ANNEX 1**RESOLUTION MEPC.397(83)**
(adopted on 11 April 2025)**AMENDMENTS TO THE NO_x TECHNICAL CODE 2008****(Use of multiple engine operational profiles for a marine diesel engine,
including clarifying engine test cycles)**

ANNEX

AMENDMENTS TO THE NO_x TECHNICAL CODE 2008

(Use of multiple engine operational profiles for a marine diesel engine,
including clarifying engine test cycles)

"Appendix IX – Flow chart for engine certification test cycle determination

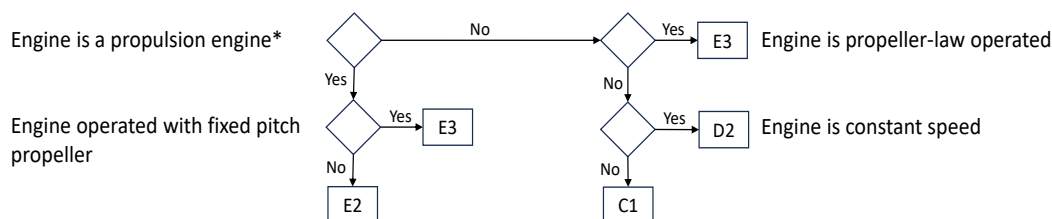
16 A new appendix IX is added as follows:

(refer to 3.2 of the Code)

Test cycle selection flowchart

* A propulsion engine may additionally perform non-propulsion duties during or separately to propulsion duties.
An engine that solely or in part provides athwartships movement of a ship is not a propulsion engine.
